SUBJECT: Morris Municipal Airport
Morris, Illinois
Grundy County
Illinois Project Number: CO9-5011
SBG Project Number: N/A
Contract No.: MR026
Item No. 01A, June 13, 2025 Letting
Addendum A

NOTICE TO PROSPECTIVE BIDDERS

Reason for Addendum:

**CONSTRUCT CROSSWIND
RUNWAY 7/25 MORRIS, ILLINOIS**

TYPICAL SECTIONS

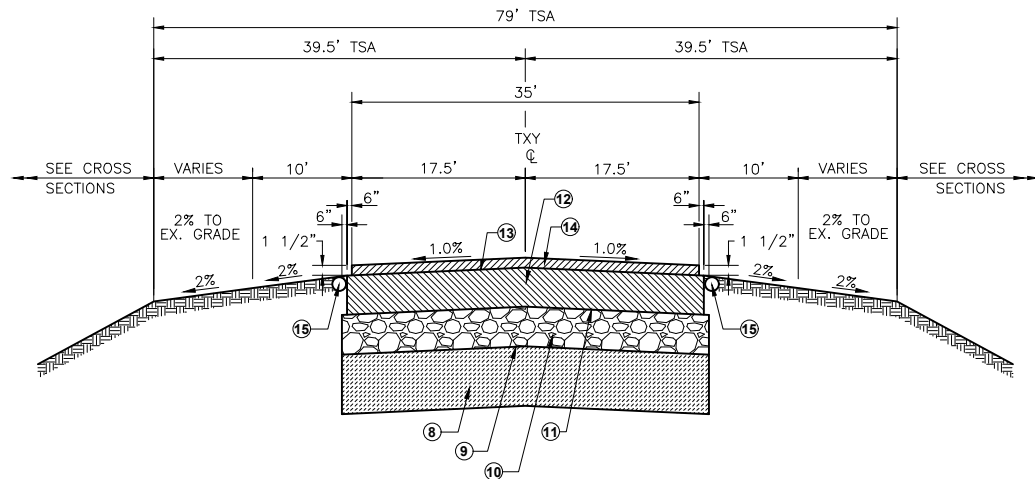
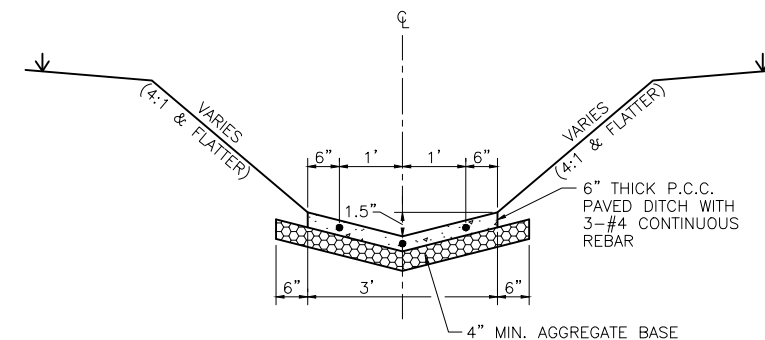
DRAWN BY: DRAWN	LEVEL	BY: CJK	DATE: 6/6/25	REVISIONS	DESCRIPTION
CHECKED BY: CHECKED				ADDENDUM TO SUBGRADE NOTE	
DATE: 6/13/2025

EXISTING CONDITIONS AND REMOVALS

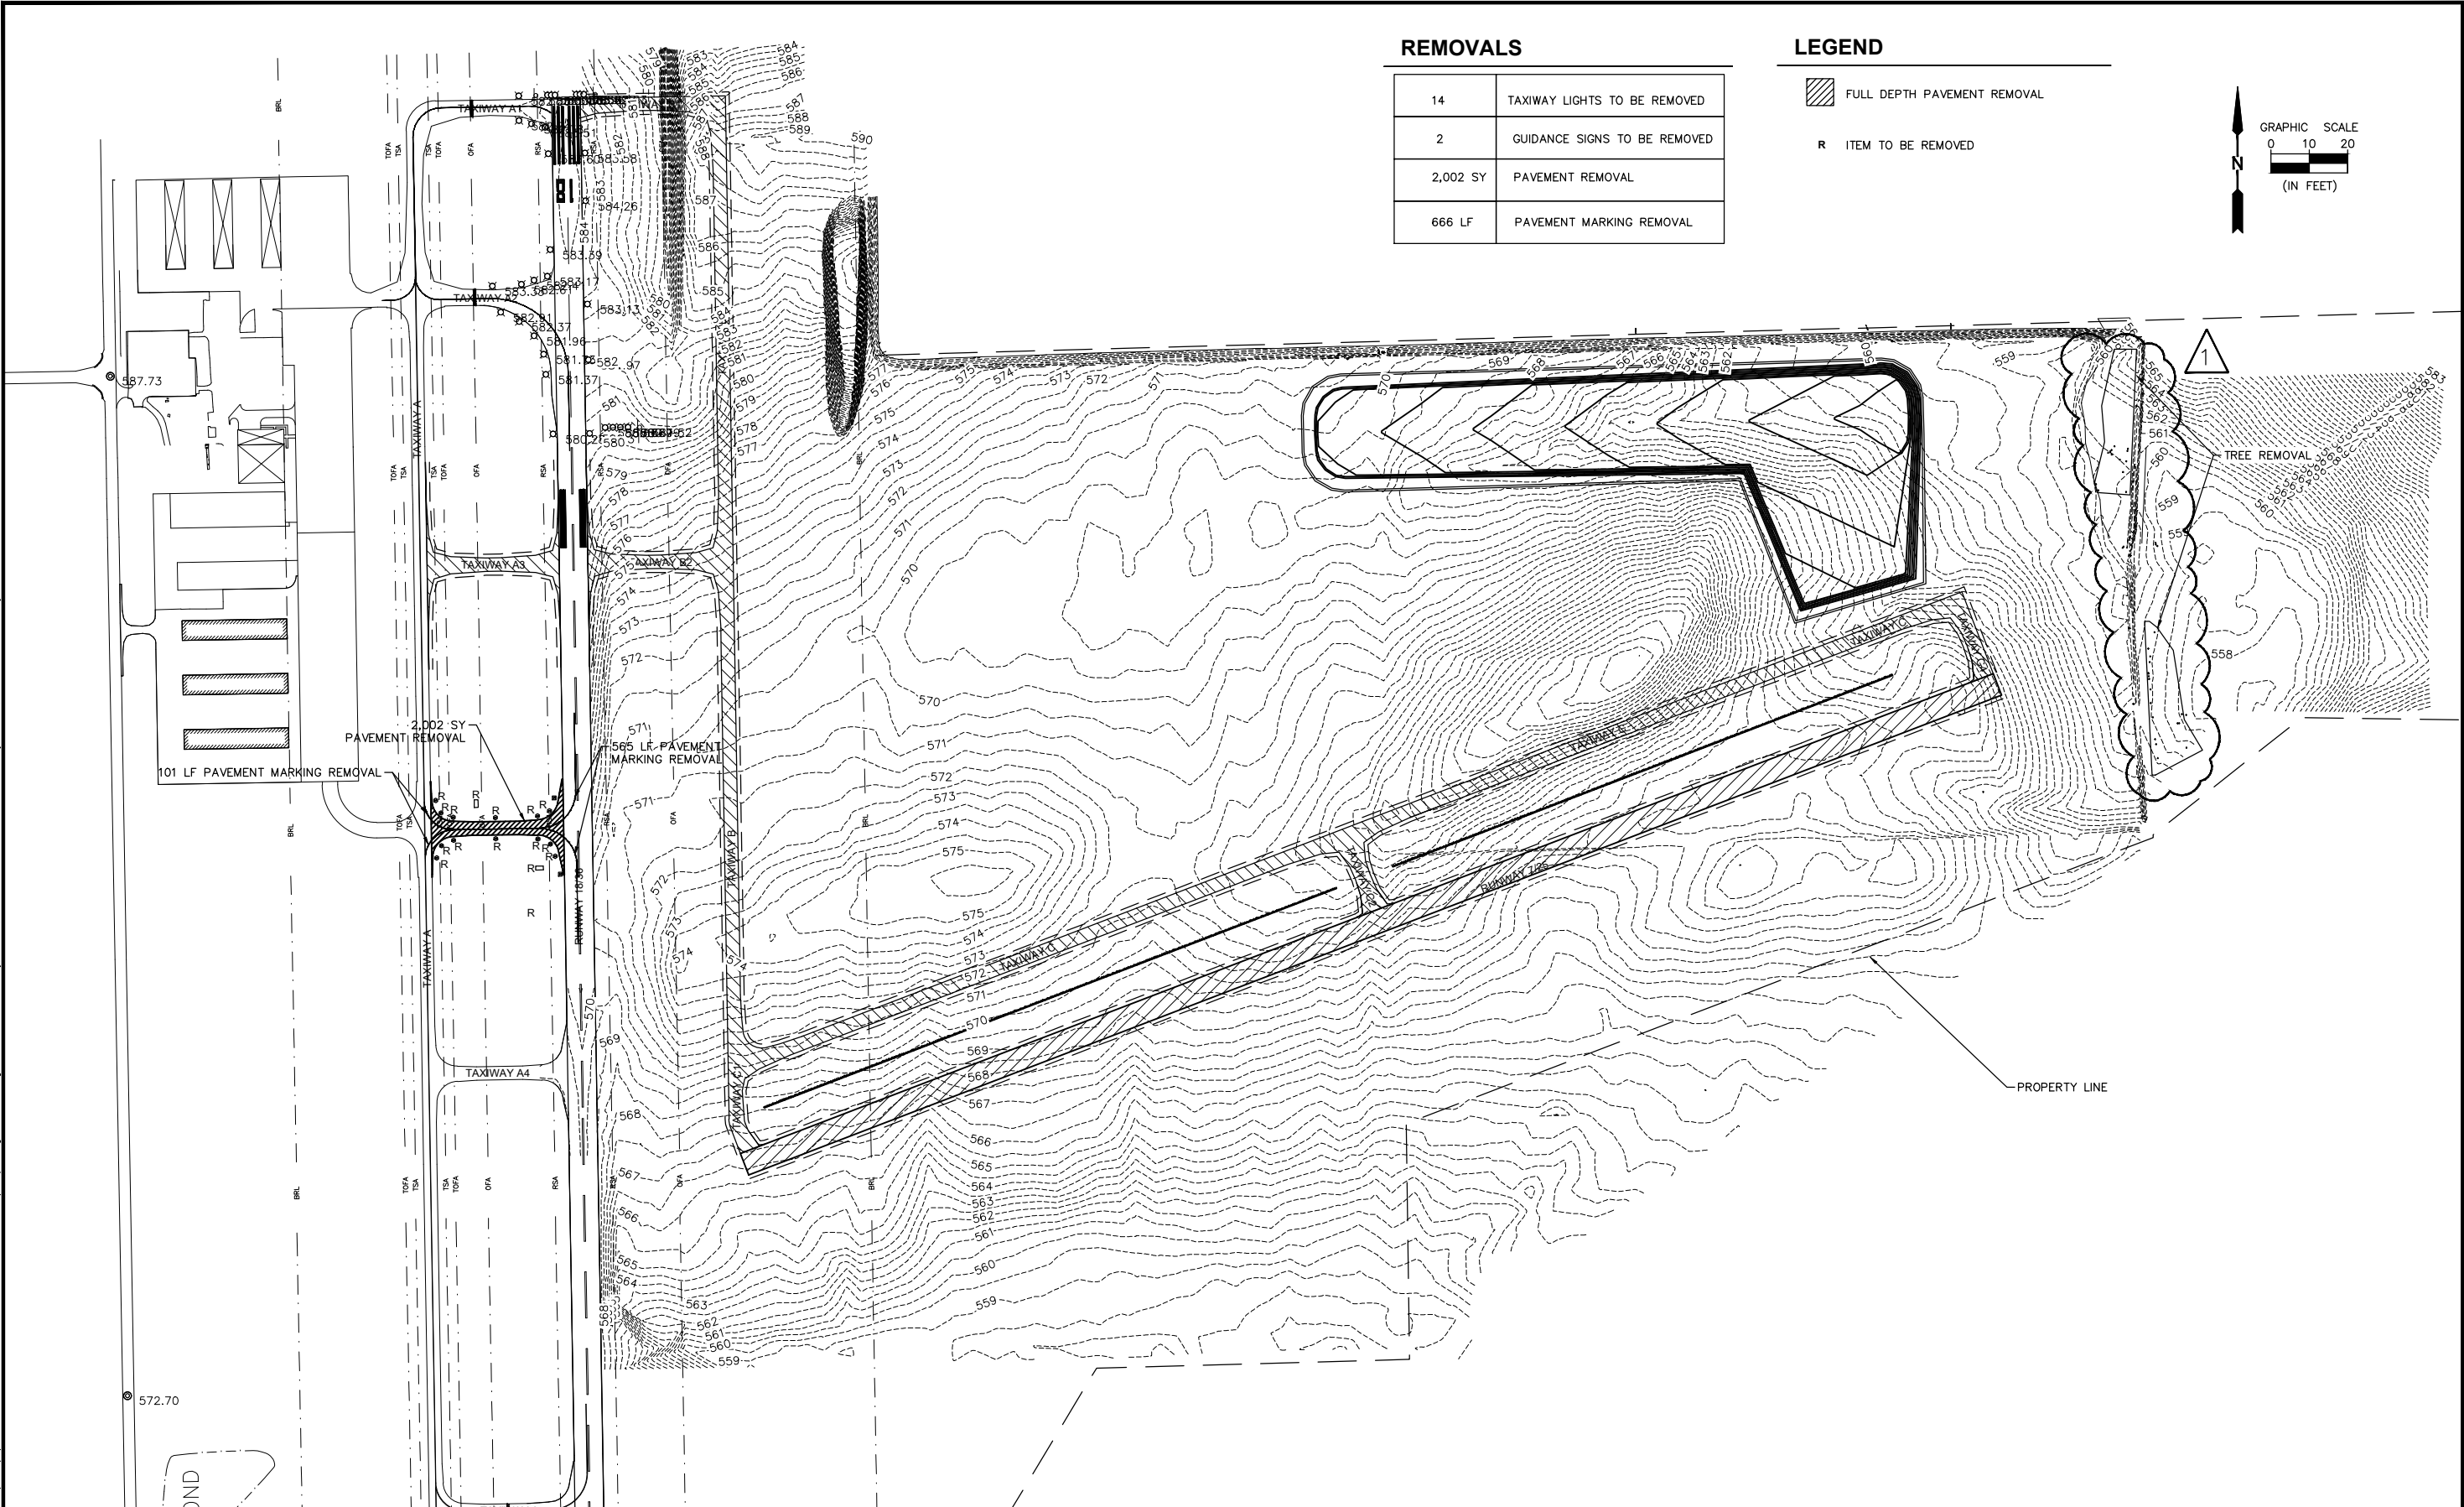
1. Sheet 2 – Summary of Quantities
 - a. Summary of Quantities table, Add Item AR151452 Clearing and Grub. 6"-More Than 2' – 2.0 Acres, Item AR156510 Silt Fence – 7155 Feet; Revise Item AR152410 Unclassified Excavation – XX Cu Yd., Item AR401614 Bituminous Surface Course – Method II, Superpave 12750 Ton, Item AR403614 Bituminous Base Course – Method II, Superpave – 16220 Ton, Item AR754610 Paved Ditch – 3000 Foot.
 - b. Added Earthwork Table to sheet.
2. Sheet 3 – Typical Sections
 - a. Revised Legend Item No. 1 to read "Prepared Subgrade"
3. Sheet 9 – Existing Conditions and Removals
 - a. Revised tree removal area.

DRAWN BY: DRAWN	LEVEL	BY	DATE	REVISIONS	DESCRIPTION
CHECKED BY: CHECKED		CJK	6/6/25	REVISED TREE REMOVAL AREA	
DATE: 6/13/2025
